KS-1 KITCHEN SINK

Project Name: Webster University-**ISB**

Copies	No.	Description
1 PDF	224216P02	(Submittal No.'s)
		(Cannon #22 4216.16-001) - (Paric #15051-) - (WES #607)
		➤ Commercial Sinks
		• Clinical Service Sink CSS-1
		• Scrub Sink SS-1
		• Sink SK-1
		• Garbage Disposer GD-1
		• Sink SK-2
		• Sink SK-3
		• Mop Sink MS-1
		• Kitchen Sinks KS-1, KS-2, KS-3

SPEC SECTION: 22 4216.16
Commercial Sinks

PFPTB101

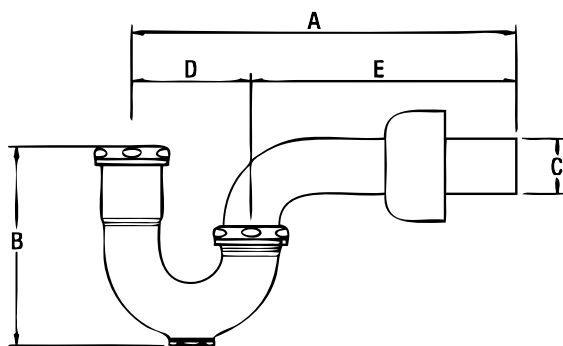
X					P-Trap Proflo Model PFPTB403	
X					Angle Stops BrassCraft Model SCR19XC	
X					Supply risers BrassCraft Model 1-12A C	
	X				Escutcheons Proflo Model PFE7	Escutcheons are specified to be cast brass. Refer to specification section 220518.
Sink SK-1						
X					Fixture Elkay Model GECR2521	
X					Faucet Chicago Faucet Model 200-AABCP	
X					Outlet Waste Disposer Kit Proflo Model PFEWB200	Provide under counter waste and supply protective piping covers as required. Verify requirements with the architectural drawings.
X					P-Trap Proflo Model PFPTB403	
X					Angle Stops BrassCraft Model SCR19XC	
X					Supply Risers BrassCraft Model 1-12AC	
	X				Escutcheons Proflo Model PFE7	Escutcheons are specified to be cast brass. Refer to specification section 220518.
Garbage Disposer GD-1						
X					Fixture Emmerson In-Sink-Erator Model Evolution Compact	
Sink SK-2						
X					Fixture Elkay Model LRAD1517	
X					Faucet Chicago Faucet Model 895-317GN2AE29ABCP
